ATA CHAPTER: 33

LIGHTS – EMERGENCY LIGHTING – CHANGE OF CIRCUIT BREAKER 2LN – EMER LT/CABIN & EXT/CTL

Mod No. 3691

Change of Circuit Breaker 2LN – Emergency Light
FIG. 1

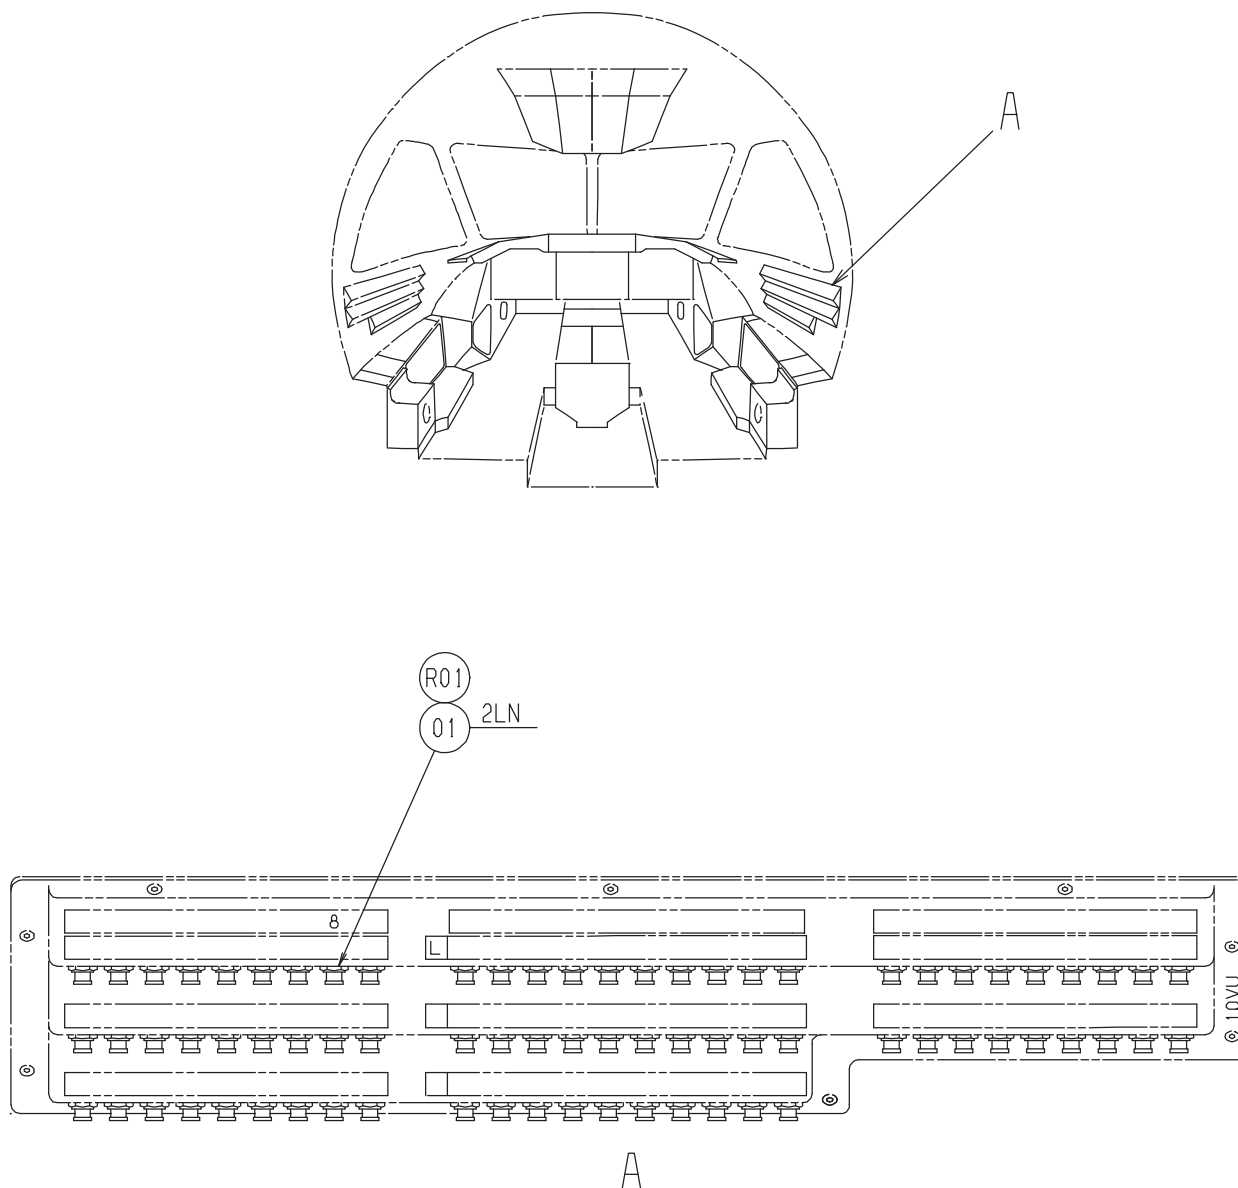
The circuit breaker for the emergency cabin lighting 2LN, in position L8, has been reported tripped without fault in the system. The following investigation found that the circuit breaker 2LN has a too low rating (5A) during max charging conditions.

In order to eliminate the tripping, without any fault in the system, this Service Bulletin will change the circuit breaker rating from the existing 5A to 7.5A.

- (1) At the RH circuit breaker panel 10VU, position L-8, remove the 5A circuit breaker (R01) EMER LT/EXT/CABIN or EMER LT/CABIN & EXT/CTL (2LN), Ref. AMM 39-10-42-02.

- (1) At the RH circuit breaker panel 10VU, position L-8, install the new 7.5A circuit breaker (01) EMER LT/EXT/CABIN or EMER LT/CABIN & EXT/CTL (2LN), Ref. AMM 39-10-42-02.
